Agenda Item # 12

SUB-002893-2024 & ZON-UDC-002892-2024

Cypress Place Subdivision

- Subdivision approval to create 209 legal lots of record.
- Rezoning from R-1 & B-3 to R-1
 - Any use permitted in the proposed district would be allowed at this location if the zoning is approved. The Planning Commission may consider other zoning districts than the proposed sought by the applicant for this property.

SITE PLAN

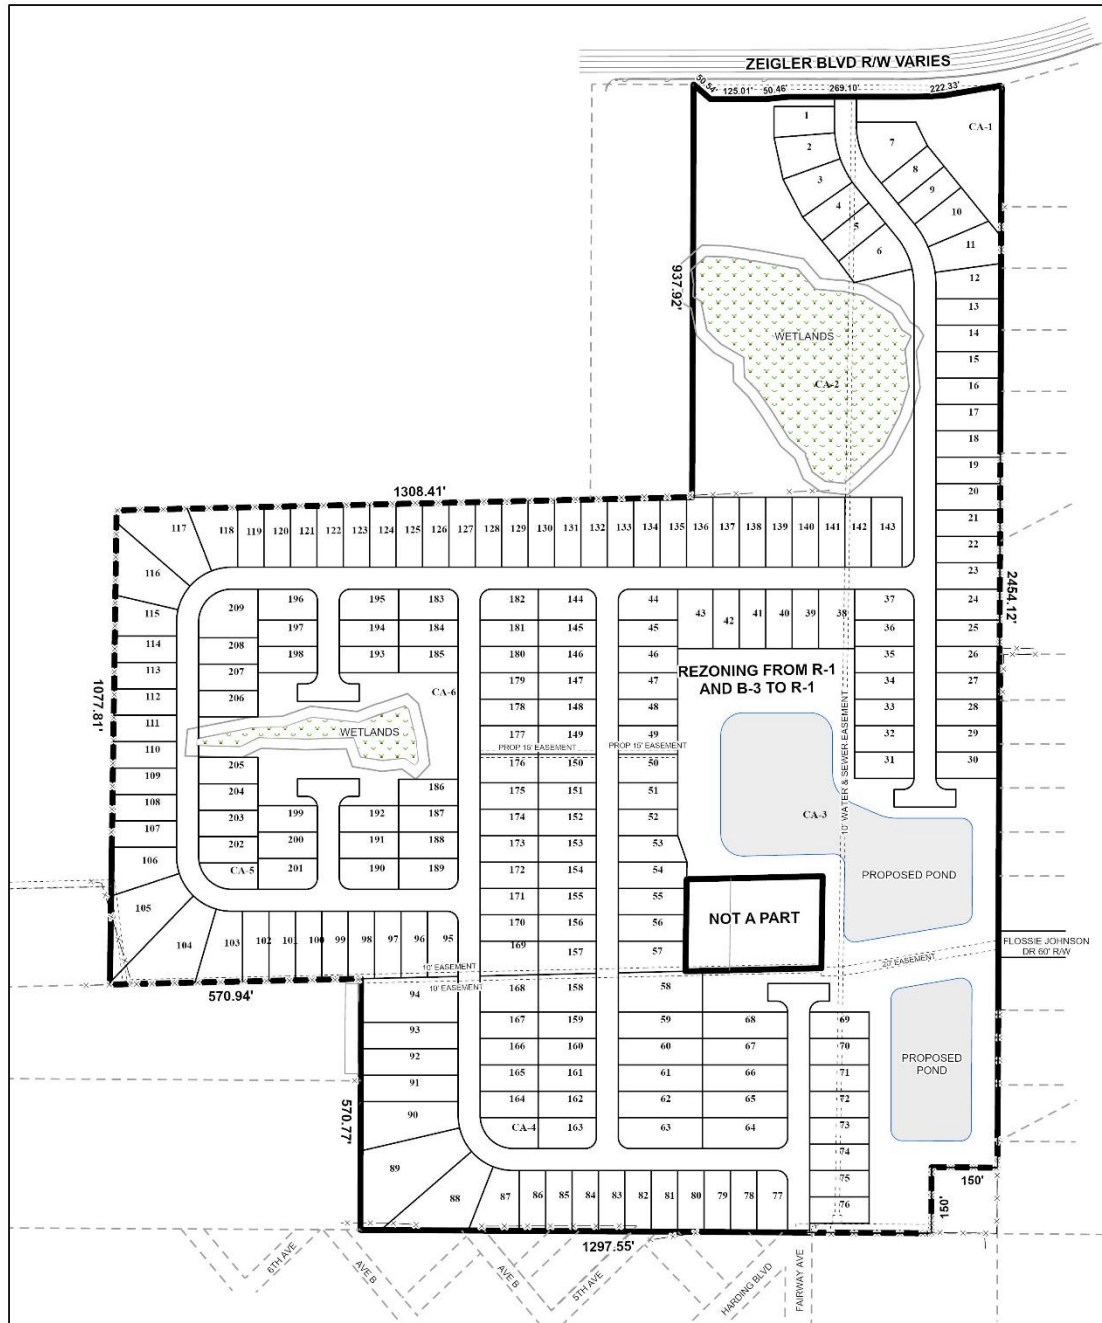
curbing and gutters requiring 50-foot wide rights-of-way. The preliminary plat depicts a varying right-of-way along Zeigler Boulevard at this location, and no rights-of-way are depicted along Harding Boulevard or Fairway Avenue. If approved, the plat should be revised to illustrate the minimum existing right-of-way width or a 100-foot right-of-way along Zeigler Boulevard (whichever is greater), and the existing rights-of-way along Harding Boulevard and Fairway Avenue.

No front yard setbacks are illustrated on the preliminary plat. Section 6.C.8. of the Subdivision Regulations requires the minimum front yard setbacks of the underlying zoning district and sub-district to be illustrated along all streets adjoining the subdivision. As such, revision of the plat should be required to illustrate a 25-foot front yard setback along each existing and proposed street where each abutting lot and common area is at least 60 feet wide, in compliance with Section 6.C.8. of the Subdivision Regulations, and with Article 2, Sections 64-2-5.E. and 64-2-14.E. of the Unified Development Code.

It should be noted that approval of the subdivision will create a landlocked parcel not associated with the request, just North of the terminus of the proposed Holly Lane. Extending the proposed street to abut the parcel would resolve this issue. As such, if approved, the plat should be revised to illustrate the proposed Holly Lane providing access to the aforementioned landlocked parcel, or the provision of a cross-access easement to the property.

Proposed Lots 81-88 abut the termini of Avenue A and 5th Avenue. These existing rights-of-way lack adequate turnarounds, as required by Section 6.B.3. of the Subdivision Regulations; however, extensions of these rights-of-way are not proposed. As such, Lots 81-88 should be denied access and a waiver of Section 6.B.3. should be considered by the Planning Commission.

1. Revision of the plat to illustrate the minimum existing right-of-way and, if less than 100 feet, dedication to provide 50 feet from the centerline of Zeigler Boulevard;

2. Revision of the plat to depict the existing rights-of-way along Harding Boulevard and Fairway Avenue;
3. Approval of the proposed street names by the City Engineer, with any modifications labeled on a revised plat;

4. Retention of the lot sizes in both square feet and acres on the Final Plat, adjusted for any required dedication;
5. Revision of the plat to illustrate a 25-foot front yard setback along each existing and proposed street where each abutting lot and common area is at least 60 feet wide, adjusted for any required dedication, in compliance with Section 6.C.8. of the Subdivision Regulations, and with Article 2, Sections 64-2-5.E. and 64-2-14.E. of the Unified Development Code;

6. Revision of the plat to extend the proposed Holly Lane, or the provision of a cross-access easement, to provide access to the landlocked parcel;
7. Approval of a waiver of Section 6.B.3. of the Subdivision Regulations for Avenue A and 5th Avenue;

8. Placement of a note on the Final Plat stating access to Avenue A and 5th Avenue is prohibited;
9. Completion of the Rezoning request to eliminate the potential for any split-zoned lots;
